Date: 15 September 2021
Reference: NEMMDR_DfTObj08
Contact: Adam Lakin
Phone:
E-mail: [REDACTED]

The Leicestershire County Council (A606 North and East Melton Mowbray Distributor Road) Compulsory Purchase Order 2020 (“CPO”)

The Leicestershire County Council (A606 North and East Melton Mowbray Distributor Road) Side Roads Order 2020 (“SRO”)

Drawing Number 60542201-ACM-STR-S3_BR_B02_Z-DR-T-0001_P03 Thorpe Brook Bridge
Indicative General Arrangement

Drawing Number 60542201-ACM-ENM-S3_GEN_ZZ_Z-DR-T-0004_P03 Indicative Proposed
NMU Routes Sheet 4 of 7

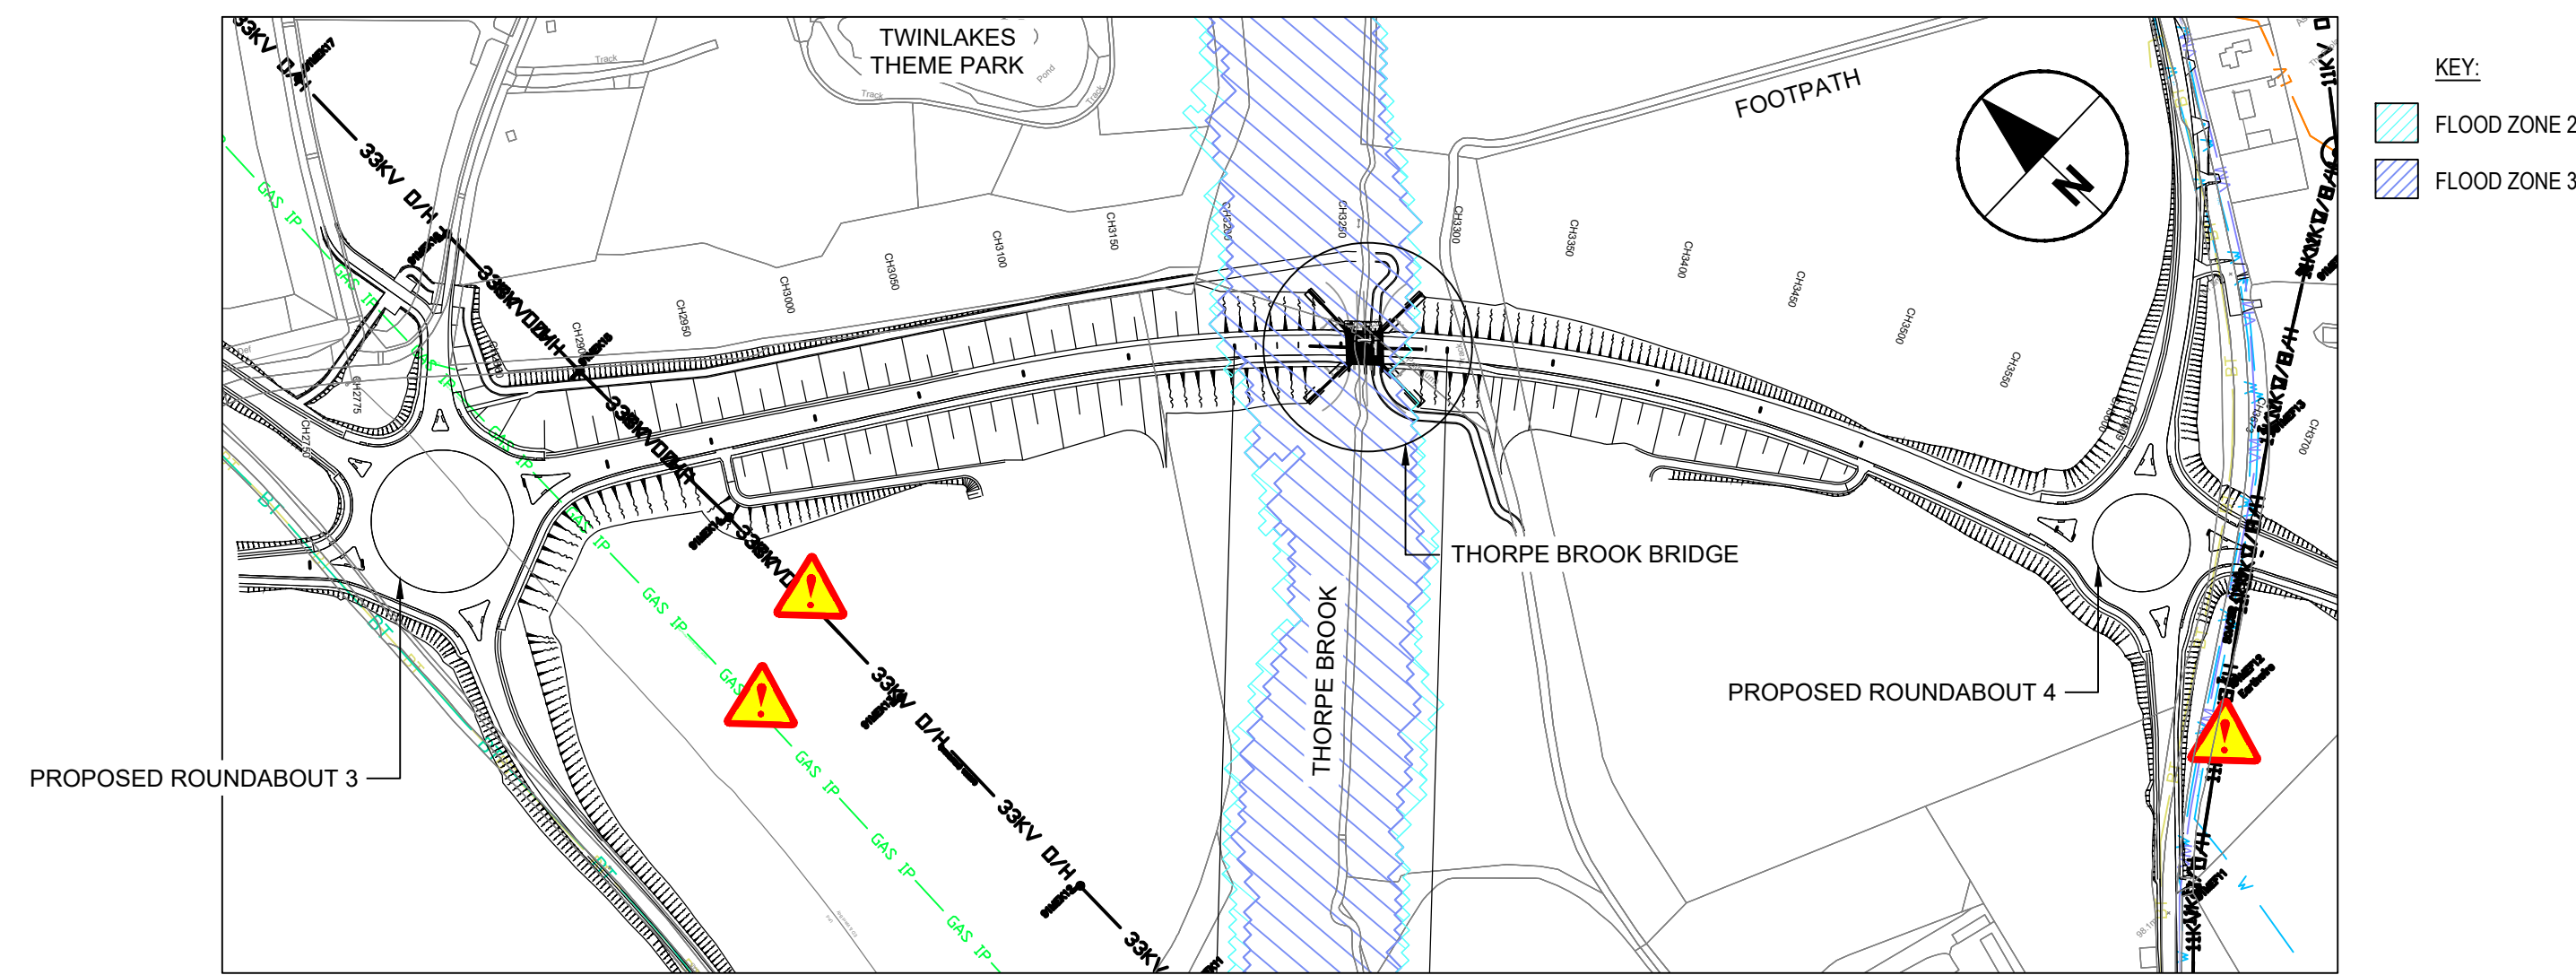
The new design segregates the bridleway from the farm access track as shown on the drawings included at Appendix A. The Council considers this to be a better solution given the concerns that you had previously expressed. I trust that it is in accordance with those discussions and provides the necessary solutions to the issues which you had identified.

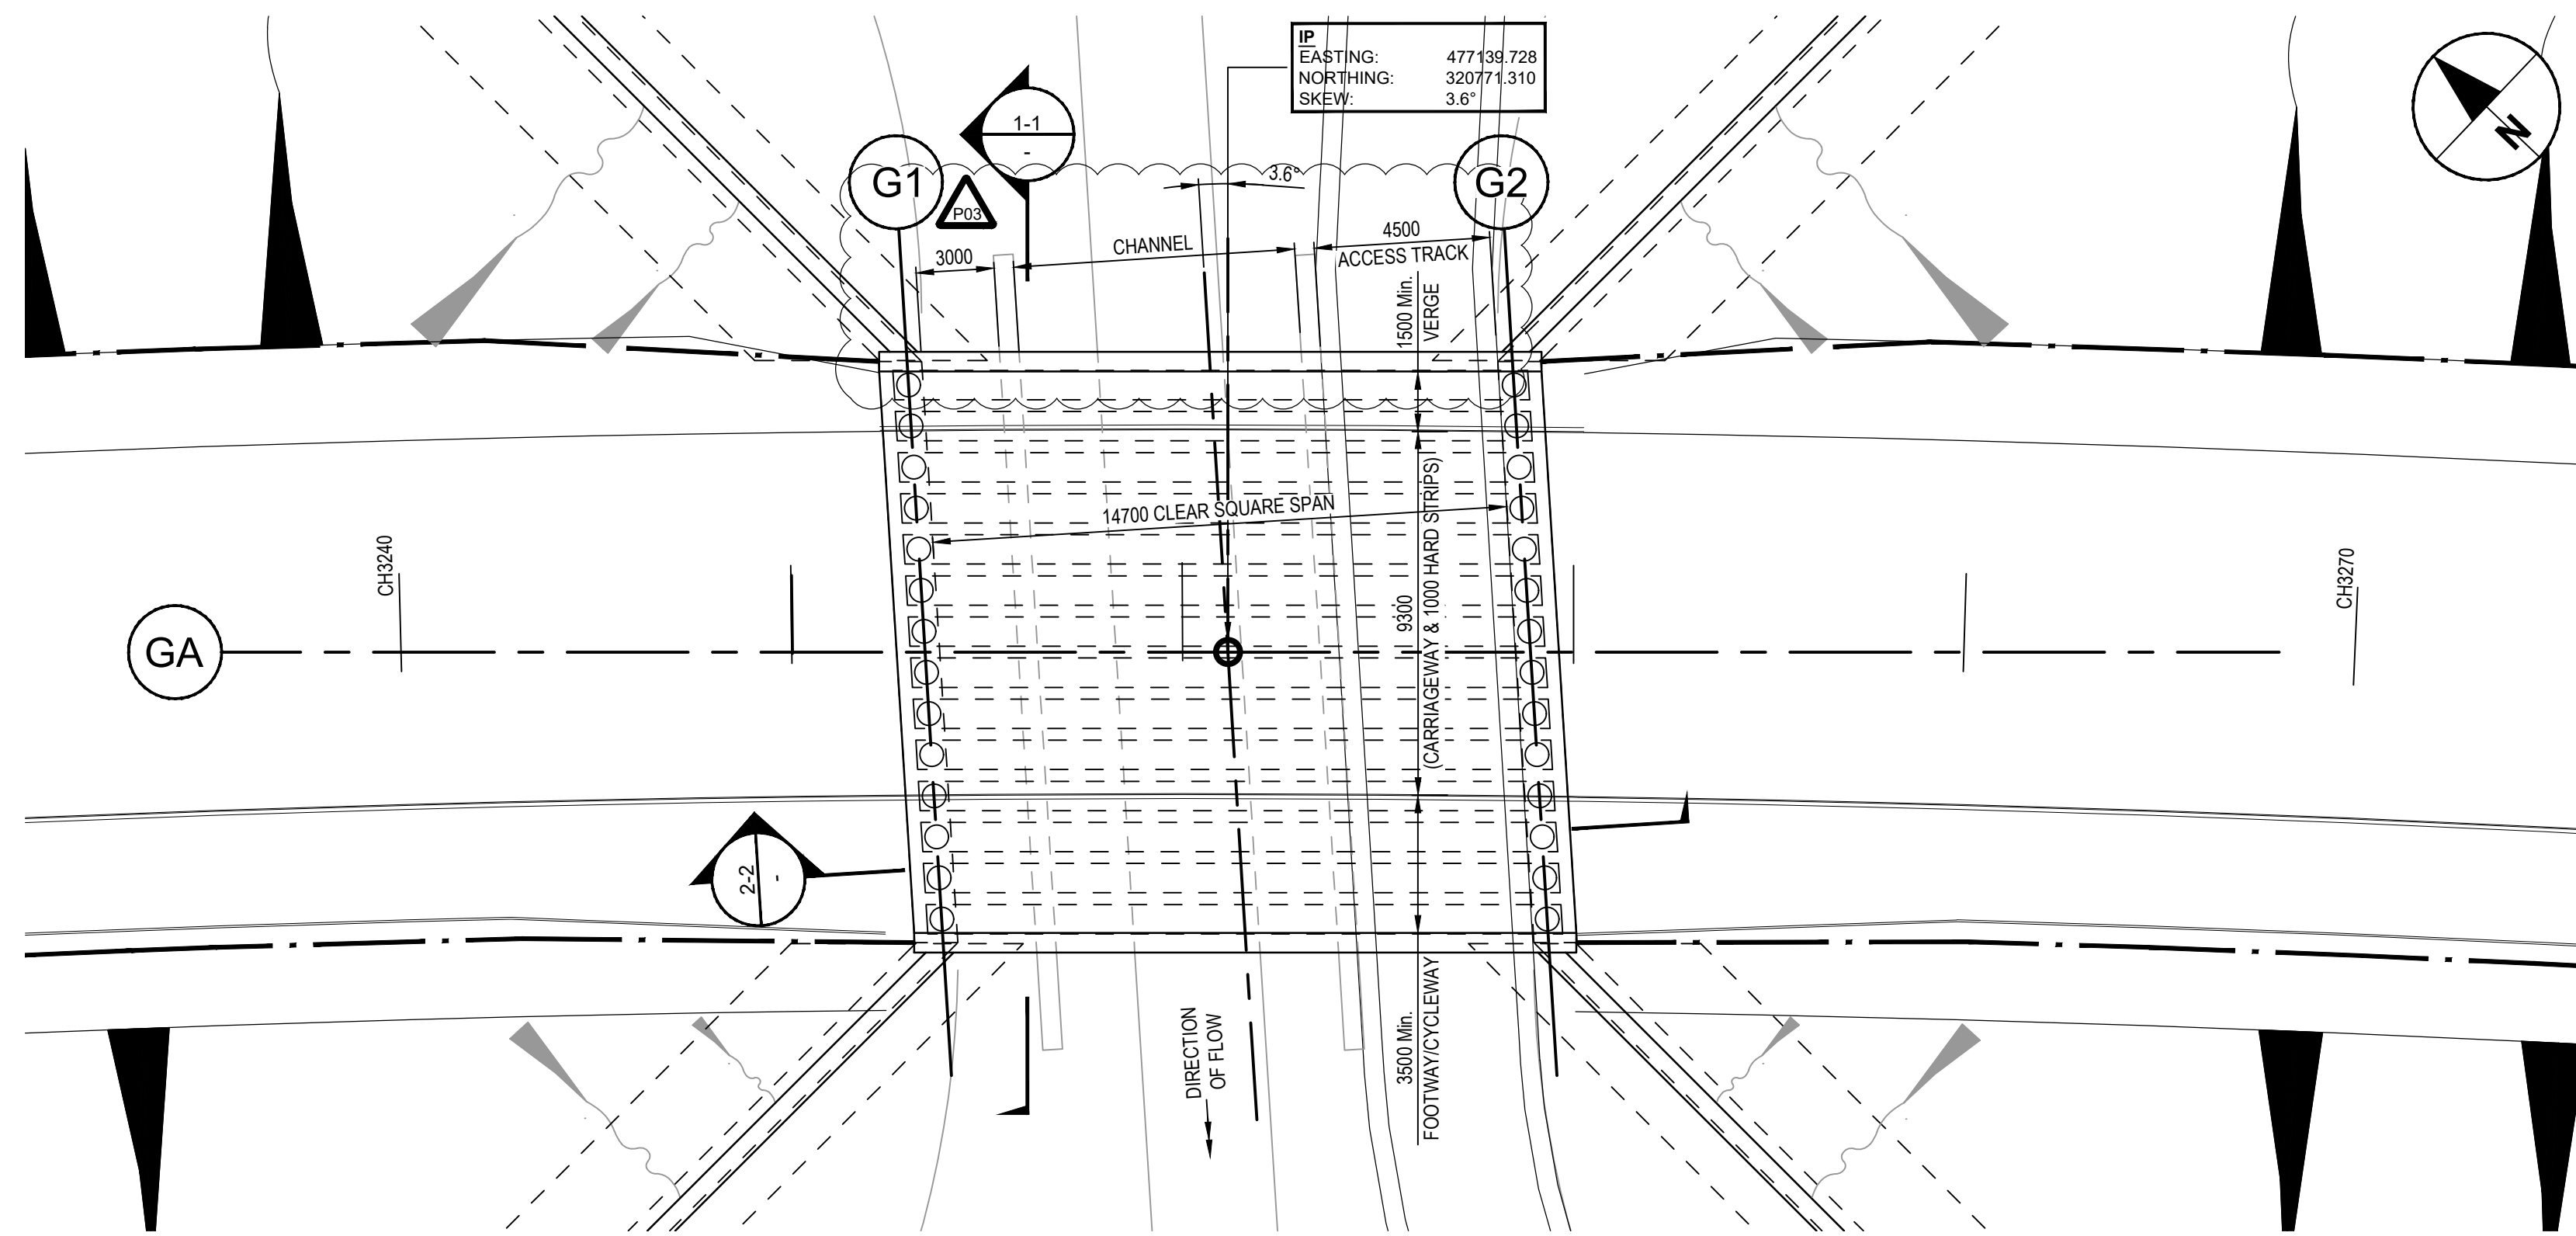
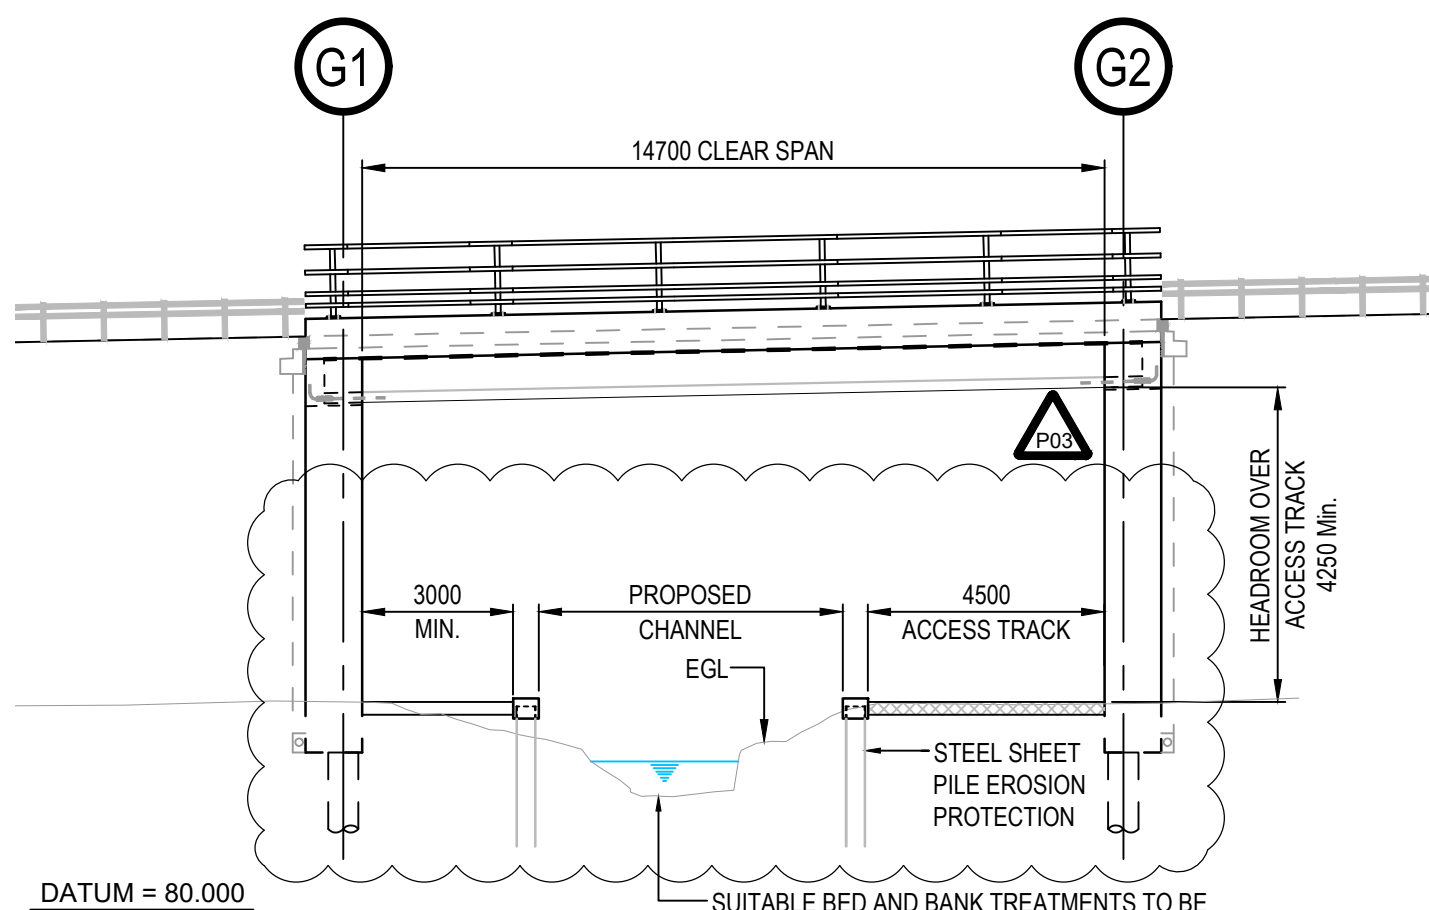
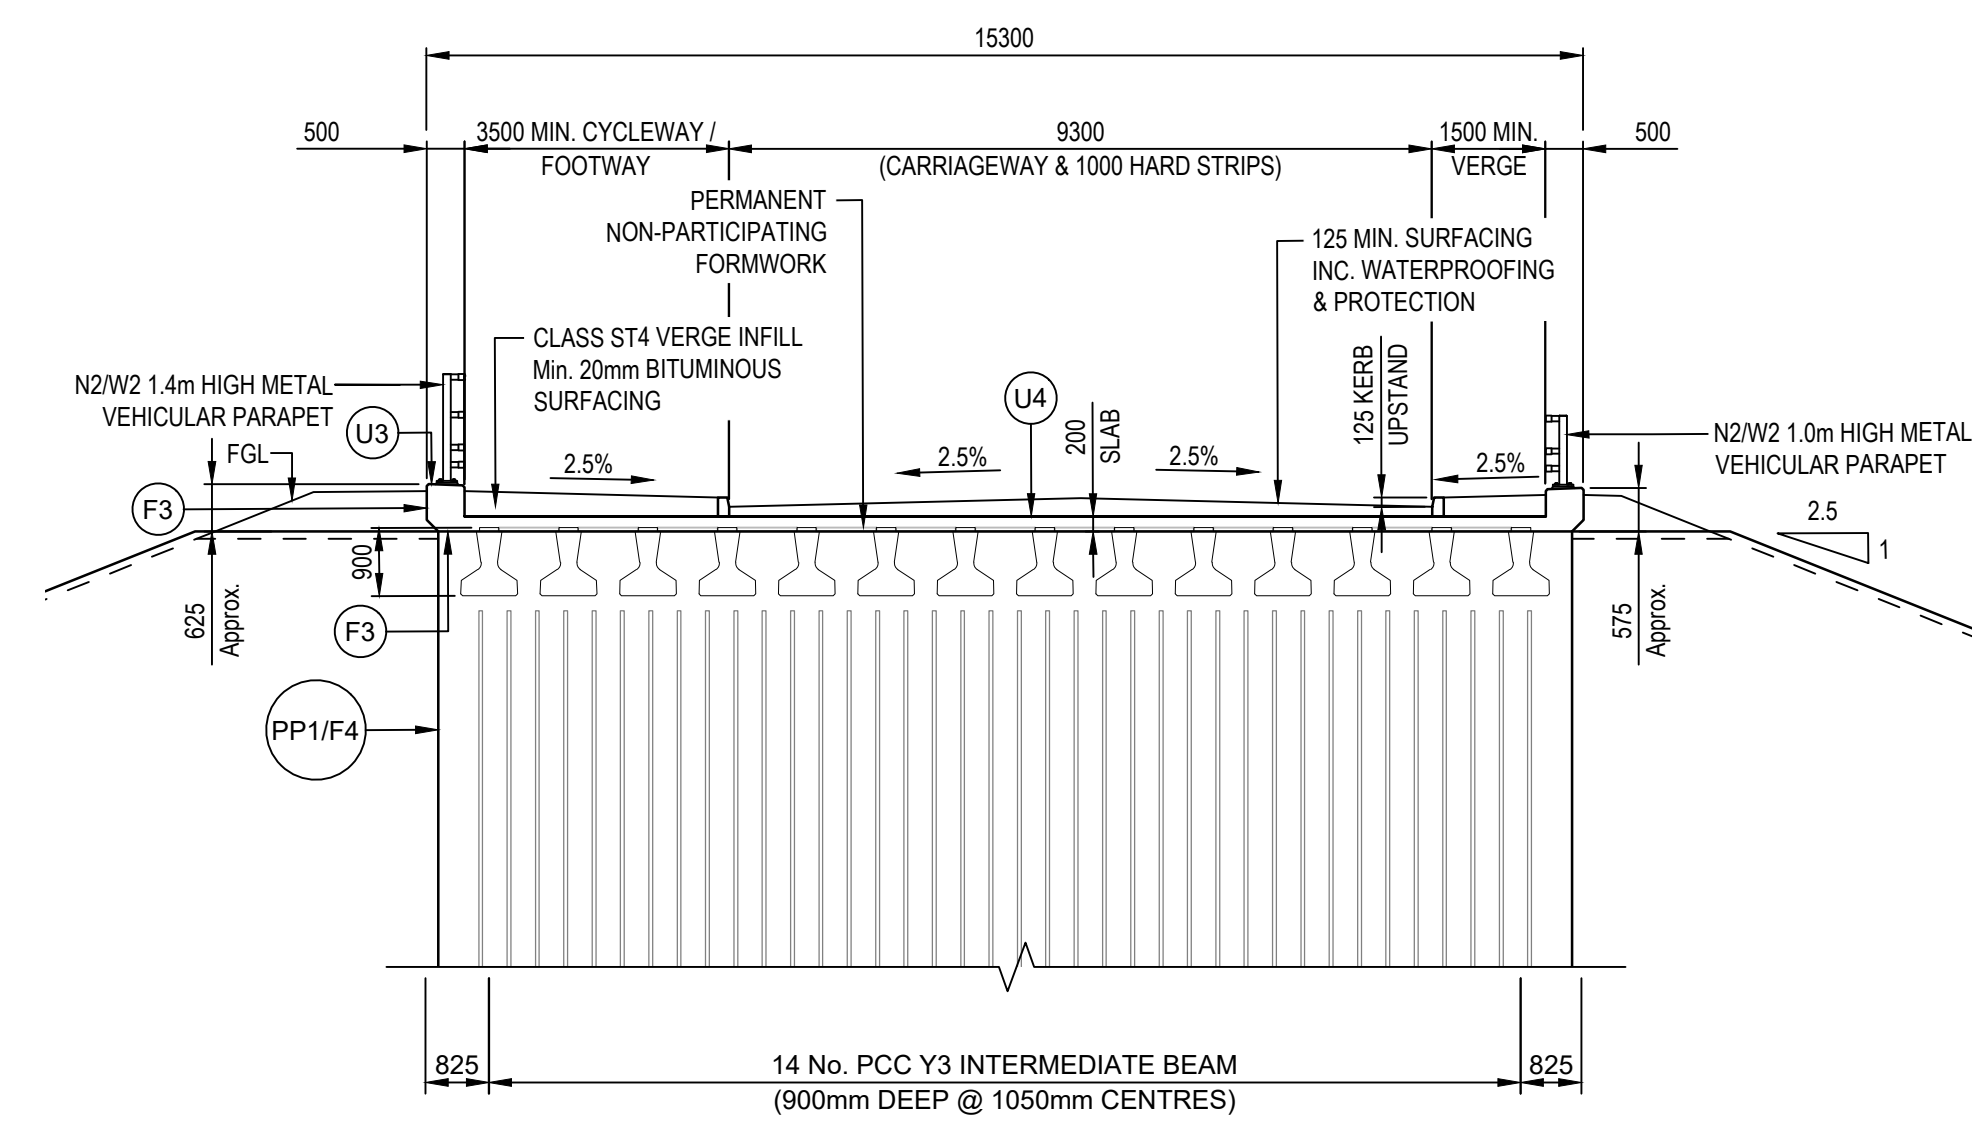
With regards to your objection to the Orders, and in particular those grounds relating to the design of the underpass at Thorpe Brook Bridge, the Council wishes to provide a formal update. We have held several virtual meetings, and have been involved in detailed discussions, regarding this matter since 2020. These discussions have resulted in the emergence of a different design at Thorpe Brook to that which was originally proposed.

The Council now intends to make a further modification to the SRO to regularise the amendments in highway terms.

Provided that the Orders are confirmed by the Secretary of State in that form, the Council will implement the new design which segregates the bridleway from the farm access track.
